# Access Compliance Report

## Public Rights-of-Way

### (Curb Ramps)

Intersection ID: 28311	Main Street: POMERANE_PL	Cross Street: ZACKERY_AV	Location: NE
ADA ID: DD8F258AEA7D	Ramp Type: PerpDiag	Initial Pass/Fail: Pass	Overall Compliance: No
			Severity Score: 10.25

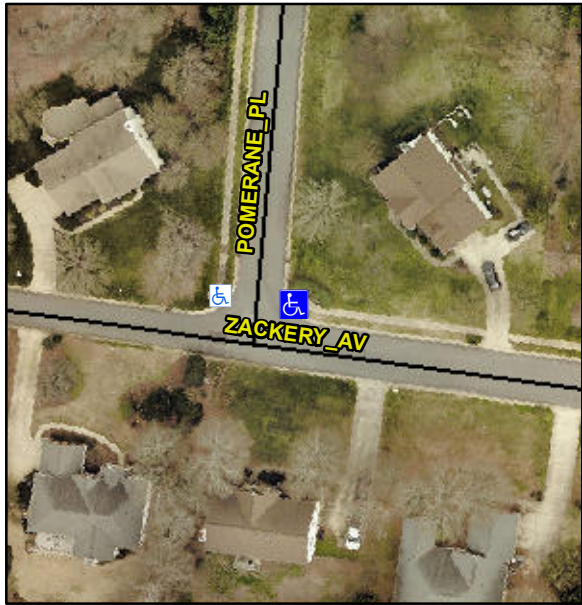
Codes/Mitigation Info/Possible Solution			Field Measurements/Component Compliance					
	Possible Solutions:		Compliance	Description	Data	Compliance	Description	Data
	<b>Remove &amp; Replace Curb Ramp With Two New Directional Ramps or Equivalent.</b>		N/A	Ramp Length (in)	41.0	Yes	Ramp Slope (%)	6.2
			Yes	Ramp Width (in)	80.0	No	Ramp XSlope (%)	2.6
			N/A	Flare Type LT	Sloped	N/A	Flare Type RT	N/A
			N/A	Flare Slope LT (%)	3.4	Yes	Flare Slope RT (%)	2.4
			N/A	Flare Traversable LT?	Yes	N/A	Flare Traversable RT?	Yes
			Yes	Landing Length (in)	54.0	No	DWS Provided?	No
			Yes	Landing Width (in)	80.0	N/A	DWS Contrast?	No
			No	Landing Slope (%)	4.0	N/A	DWS Length (in)	N/A
			Yes	Landing X Slope (%)	1.6	N/A	DWS Full Width?	No
		N/A	Landing Curb? (Y/N)	No	N/A	DWS Offset (in)	N/A	
		N/A	Shared Landing?	No				
		Yes	Gutter Ponding?	No	Yes	Gutter Slope (%)	3.8	
		Yes	Gutter Lip Ht (in)	0.0	Yes	Gutter X Slope (%)	0.2

N/A	Painted X Walk1?	No	N/A	Painted X Walk2?	No	
			X Walk 1 Direction	To NW		X Walk 2 Direction	To S	
		N/A	X Walk 1 Width (in)	N/A	N/A	X Walk 2 Width (in)	N/A	
			X Walk 1 Slope (%)	5.1		X Walk 2 Slope (%)	1.5	
			X Walk 1 X Slope (%)	1.2		X Walk 2 X Slope (%)	3.2	
		N/A	Ramp inside XWalk1?	N/A	N/A	Ramp inside XWalk2?	N/A	
			Road Slope (%)	3.0	N/A	Clear Space?	Yes	
			Road X Slope (%)	6.7	N/A	Clear Space to XWalk (in)	N/A	
		Yes	Any Obstructions?	No	Yes	Storm Grate/Utility Hazard?	No	
			Obstruction Type			Storm Grate/Utility Type		
				N/A			N/A	
					Yes	Surface Condition? (G/P)	Good
